ECE/TRANS/WP.29/2009/9  
18 December 2008

Proposal for Supplement 7 to Regulation No. 106  
(Pneumatic tyres for agricultural vehicles)

Submitted by the Working Party on Brakes and Running Gear \*/

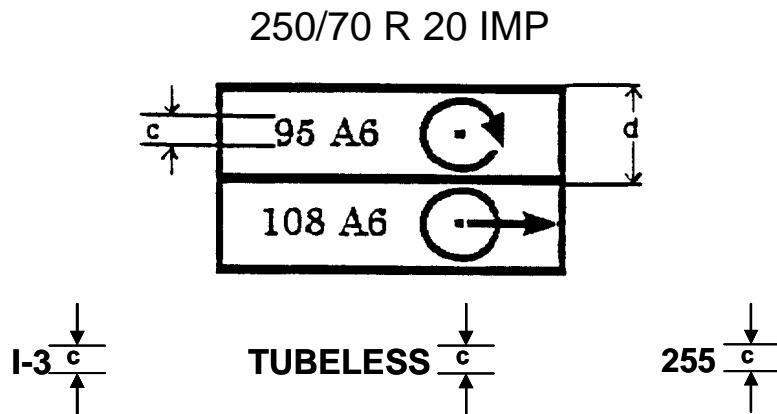
Annex 3, part C, amend to read:

"PART C: IMPLEMENT TYRES

Example of the markings to be borne by types of tyres  
complying with this Regulation

MINIMUM HEIGHTS OF MARKINGS (mm)

.....

- (c) the symbol "TUBELESS", I-3 if any, the optional word "RADIAL", the optional word "IMPLEMENT" and the date of manufacture may be at a distance from the size designation."
